AMENDMENT

16-43725-AMD-1
February 9, 1993

MORTAL KOMBAT Kit, using the T-Unit CPU

This amendment updates the Mortal Kombat Manual. Please place this information in the manual.

Notice: Power Supply

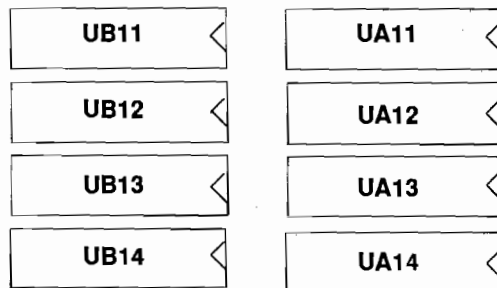
Be sure the power supply from your old game is capable of +5V dc at 5A and +12V dc at 2A.

Typical Cabinet Wiring

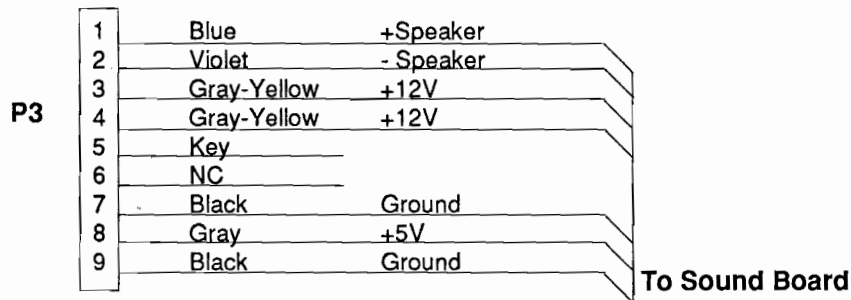
The connector P3 on the CPU should be changed to the following.
